Re: Petition No. Petition 1337 - Stepstone to Greenhill Upgrade Project

Stepstone to Green Hill Upgrade Project

Data Request CSC-01
Dated: 12/14/2017
Q-CSC-002
Page 1 of 1

Madison, CT
Map Sheet 8 of 9

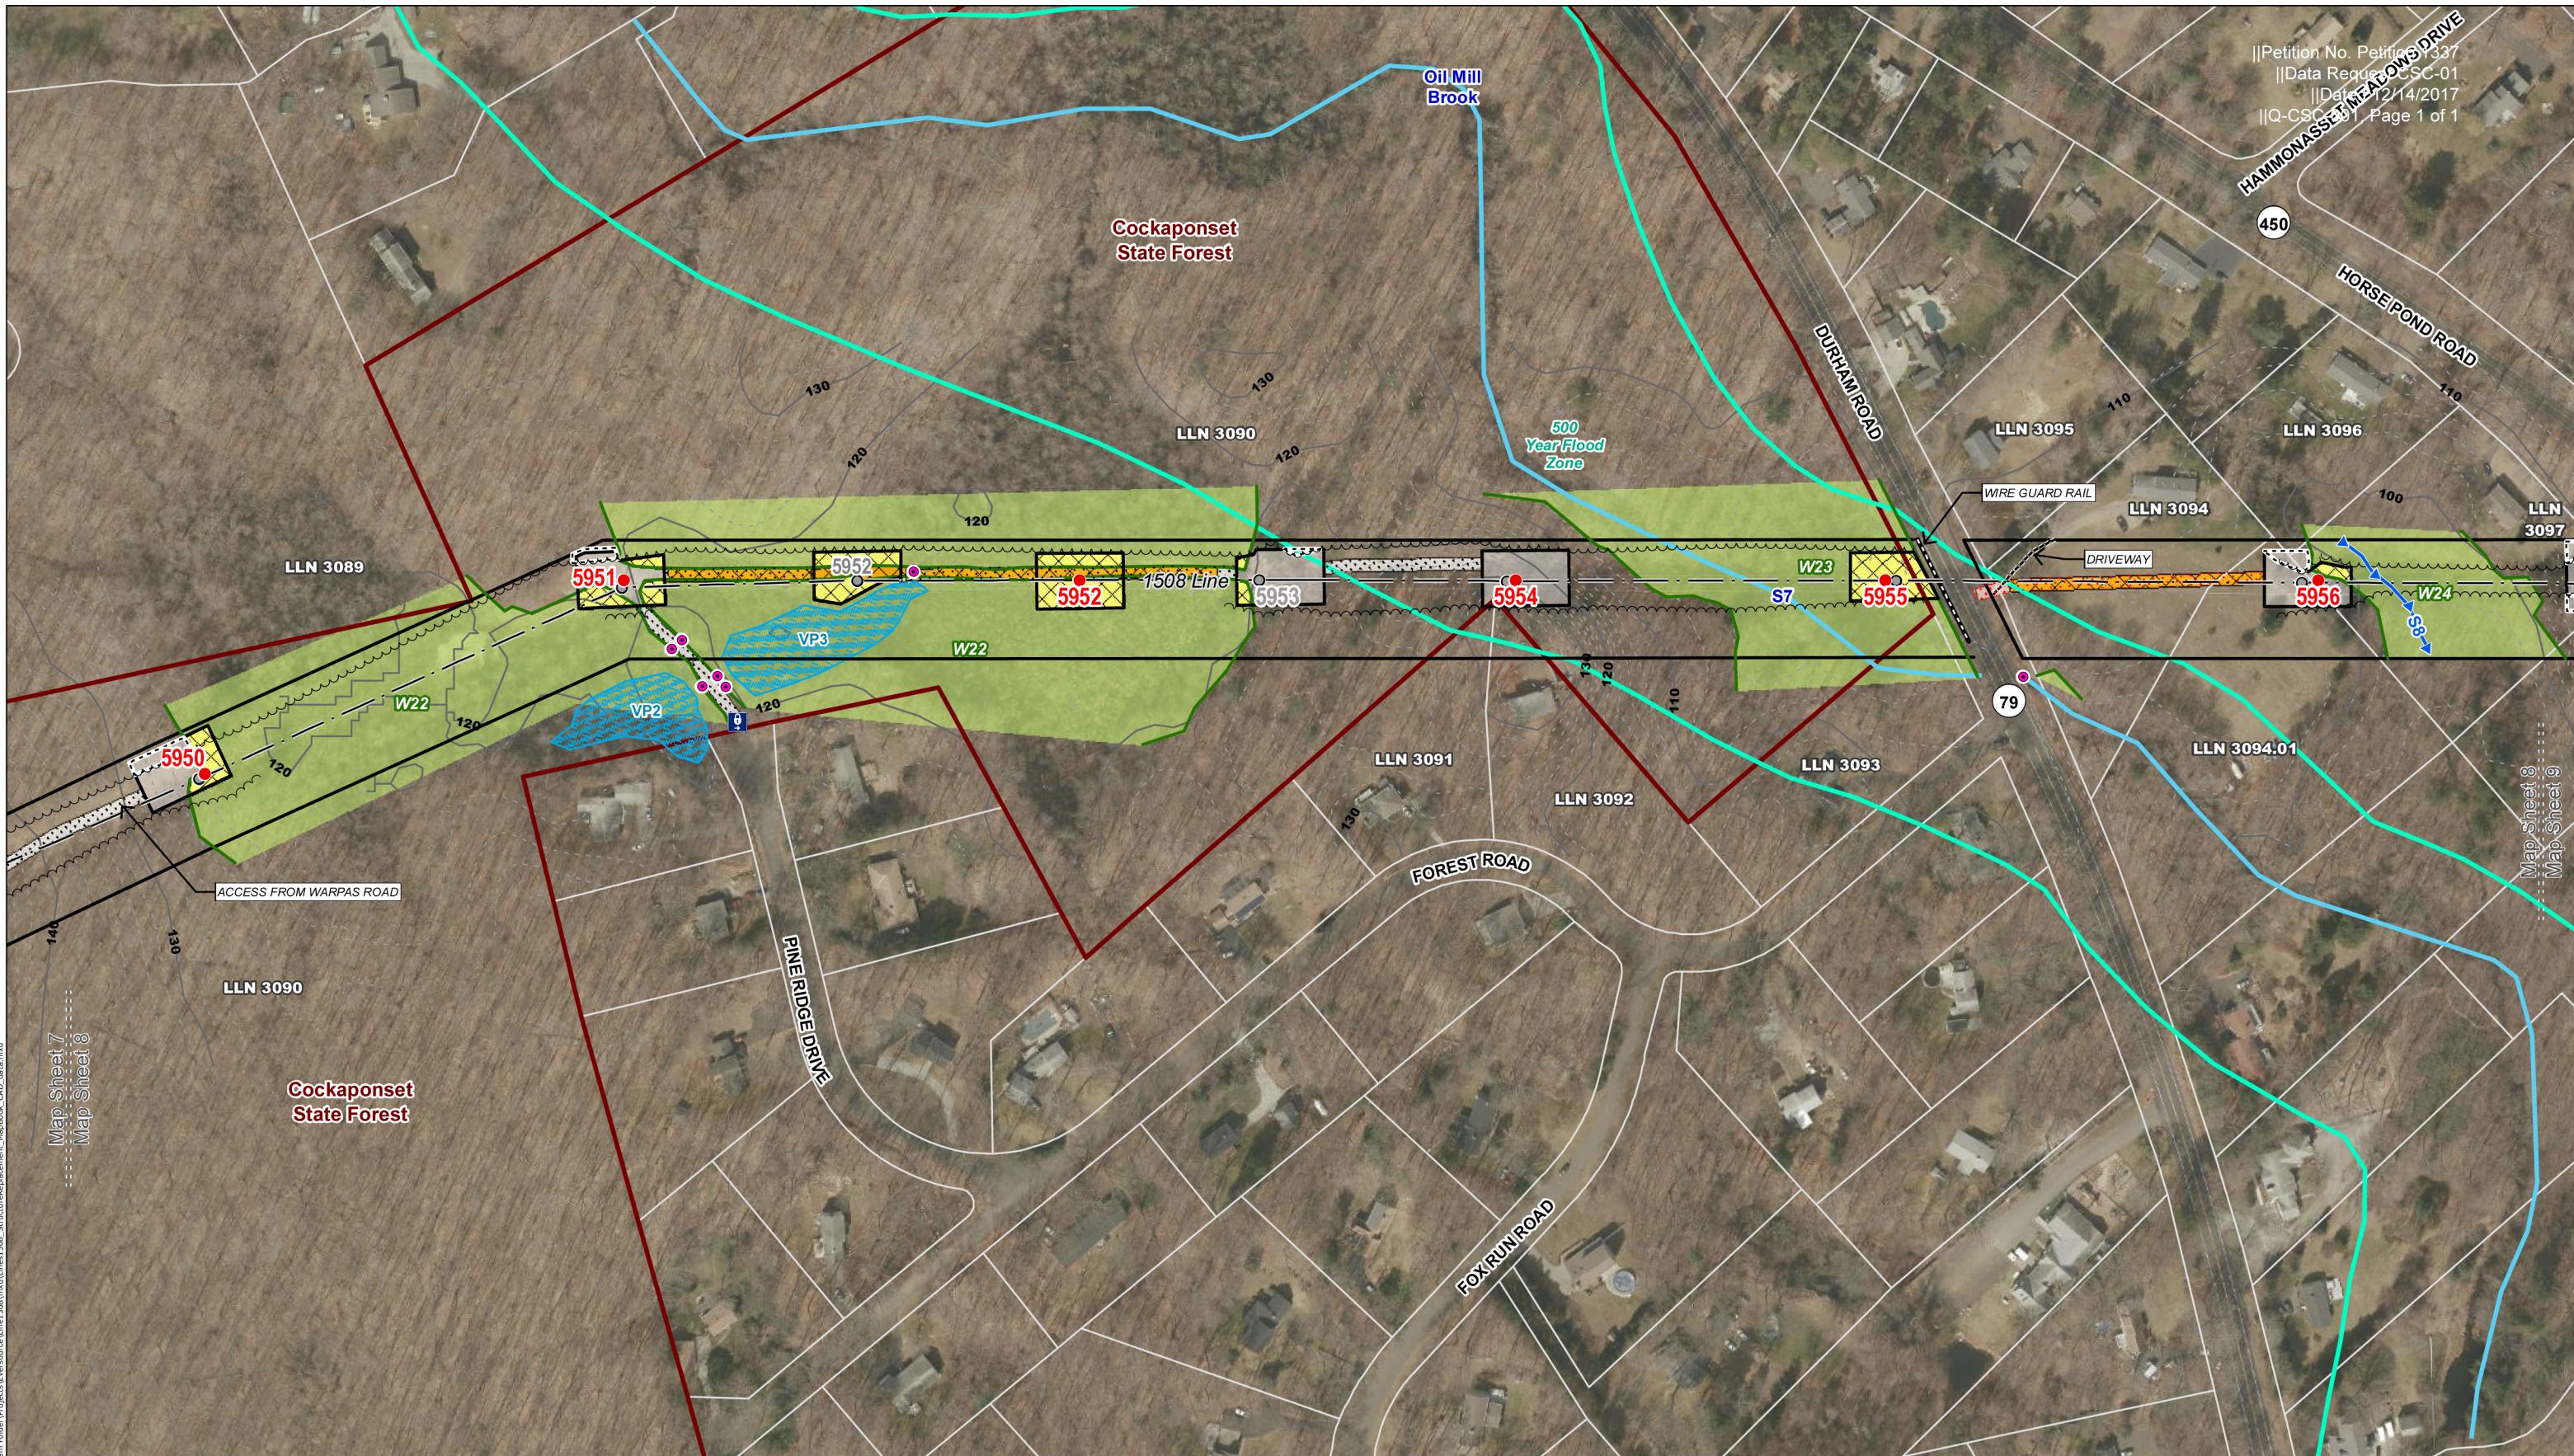
Map sheet 8 of the petition illustrates Structure 5952 is adjacent to vernal pool 3. Is it possible to eliminate structure 5952 and shift structure 5953 west to compensate for a practical span length to structure 5951 or in the alternative shift structure 5952 and work pad further east away from the vernal pool?

To further reduce the potential impacts to vernal pool 3 near structure 5952, Eversource proposes to relocate structure 5952 approximately 280 feet east from the existing location and remove proposed structure 5953. This alternative shift will avoid vernal pool 3 and will not require any tree clearing or structure height increase.
